Missoula City-County Health Department
WATER QUALITY DISTRICT
301 West Alder Street | Missoula MT 59802-4123
www.missoulacounty.us/HealthDept
Phone | 406.258.4890
Fax | 406.258.4781

April 2, 2018

Re: Draft HHRA OU2 and OU3, BERA OU2 and OU3

(Montana DEQ Solid Waste Program Files – 1992 Inspection – note layering of ash/sludge)

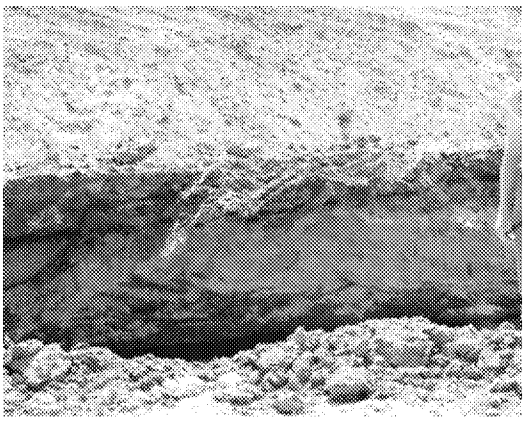
- As pointed out in previous comments, the mill bleached approximately 30% of its product in early years of production (see photo). This needs to be corrected in the site overview. Most subsurface samples were collected from 24- 30 inches. Deeper samples are needed to characterize older layers deposited when bleaching was at its peak and substances like PCBs were in common use.

(DEQ Solid Waste Management Program Files 1992 inspection)

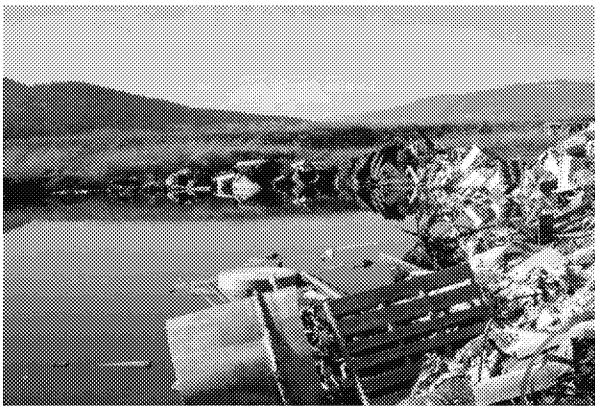
- The solid waste basins were documented to be in contact with groundwater. This is significant and should be thoroughly investigated prior to developing a risk assessment. Peak seasonal groundwater elevations should be determined, and sampling should be conducted during peak seasonal groundwater conditions.

- This section fails to identify that landfills and storage ponds are a source of contamination to groundwater (see photos section 2.3 comments).
- Methane gas has been an issue at several of Missoula's cleanup sites including White Pine and Sash, Hart Refinery and The Missoula Sawmill. This risk to future residents and occupants of the site has not been evaluated. The 2014 site investigation driller logs and field notes document multiple instances of sulphur odors and methane, which were confirmed by photo-ionization detectors. These are considered landfill gasses and must be evaluated as part of landfill closure.
